TENNESSEE VALLEY AUTHORITY

WATTS BAR NUCLEAR PLANT (WBN) - NRC INSPECTION REPORT NO. 390, 391/90-14 -
REPLY TO NOTICE OF VIOLATIONS 390/90-14-01 AND 390/90-14-02

RESPONSE TO NRC NOTICE OF VIOLATION
390/90-14-01

WBN INTAKE PUMPING STATION - FIRE PROTECTION PUMP DISCHARGE (TRAIN A)

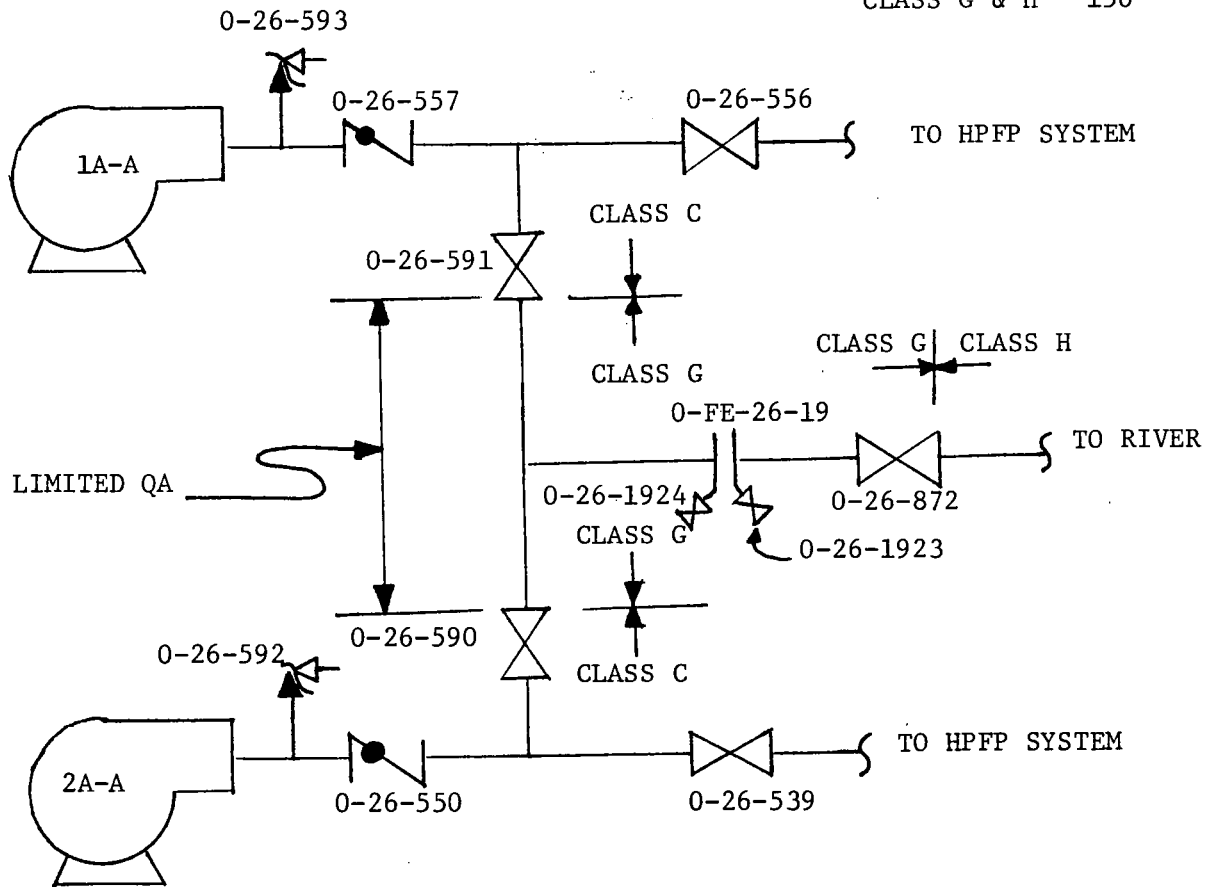
Contrary to the above, Instruction Change 90-200 to Surveillance Instruction (SI)-7.50 was technically inadequate in that it instructed gagging of the "A" train high pressure fire system relief valve which resulted in a portion of the system piping between the pump discharge and the flow line test throttle valve 0-26-871 exceeding the design pressure.

TVA admits the violation occurred, but would like to provide the following clarification. The portion of the piping system for which the design pressure was exceeded is Class G (non-ASME) and is bounded by valves 0-26-590, 0-26-591, and 0-26-872 (see attachment). The piping from the pumps to valves 0-26-590 and 0-26-591 has a rated design pressure of 200 psig. The only piping affected by the excessive pressure was the test header, not the high pressure fire protection header.

Under the corrective action for Condition Adverse to Quality Report (CAQR) WBP 900290P, the design organization will revise the design pressure of the subject fire protection test line to meet testing requirements.

The design pressure of the fire protection test line will be revised by October 31, 1990.
